GOLDEN GATE BRIDGE and HIGHWAY DISTRICT
SAN FRANCISCO, CALIFORNIA

THE AMMANN & WHITNEY REPORT, AUGUST 1964;
THE TUDOR ENGINEERING COMPANY REPORT, MARCH 1966:
RELATING TO THE INSTALLATION OF A LOWER DECK FOR
VEHICULAR TRAFFIC ON THE
GOLDEN GATE BRIDGE

CLIFFORD E. PAINE

MAY 1966

The Bottom Lateral Truss

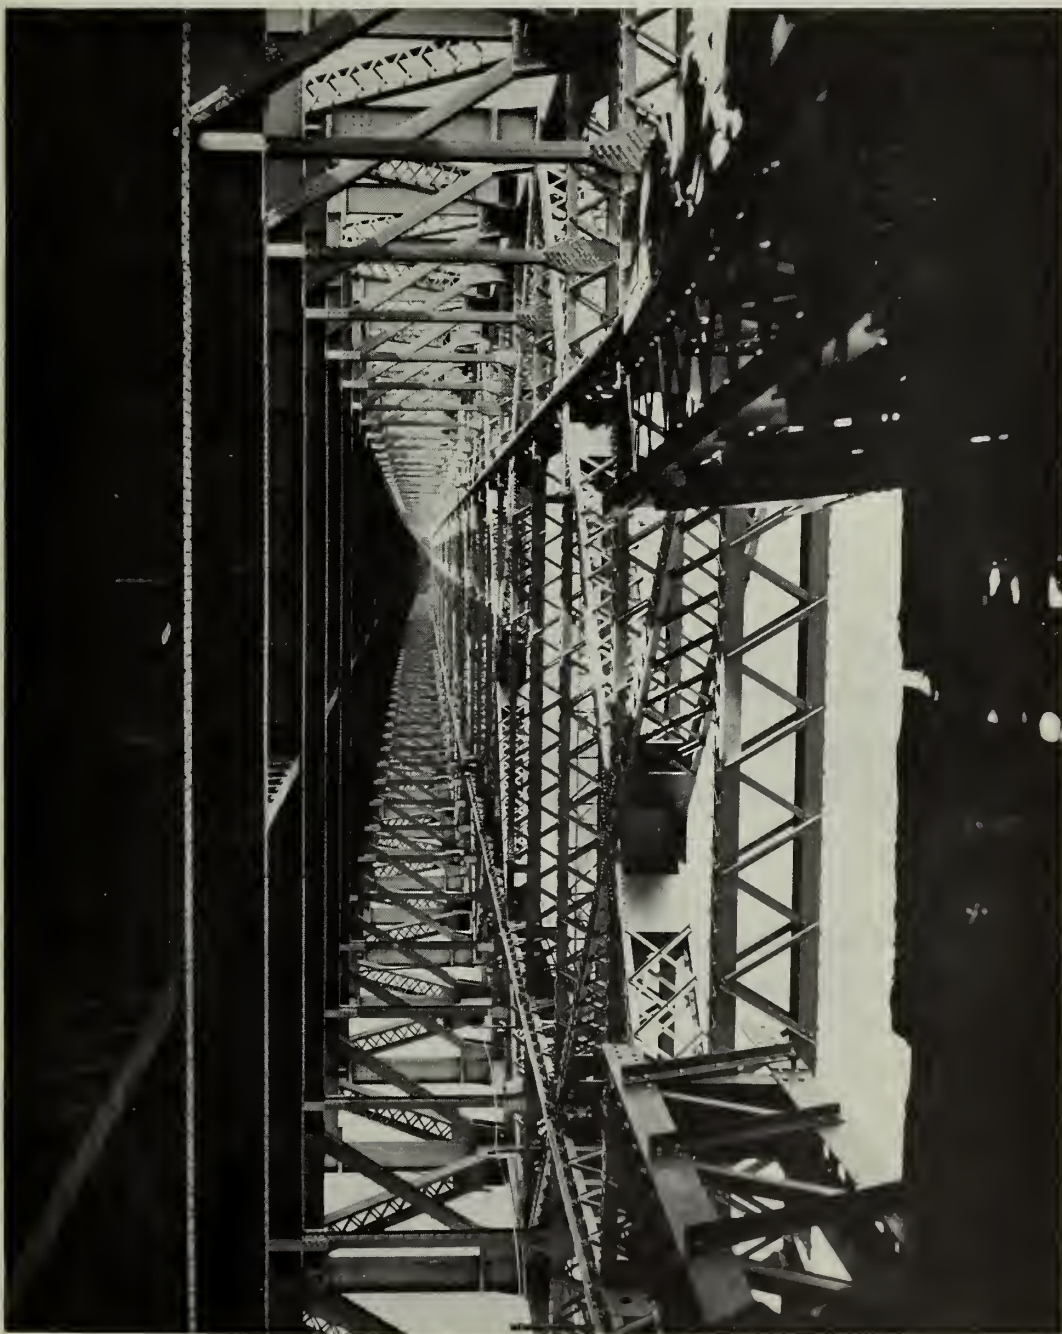
The bottom lateral trusses were installed at a cost in excess of \$3,000,000. Their sole purpose was to provide the suspended spans with great torsional resistance. They do not carry transverse wind loads to the towers. This is done by the top lateral system.

Before the bottom lateral trusses were installed a cross section through the suspended spans could be likened to an inverted U formed by the top laterals and the two stiffening trusses. By closing up the open side of the inverted U the bottom lateral truss changes the cross section from a three sided figure to a closed, four sided figure. In order to function properly it is essential that

the bottom chords of the stiffening trusses form the chords of the bottom lateral trusses just as the top chords of the stiffening trusses form the chords of the top lateral truss. It is also essential that the cross sections at panel points be maintained rectangular. The kneebraces do this effectively. Since the system was installed over ten years ago the suspended spans have been free of torsional vibrations of high amplitude.
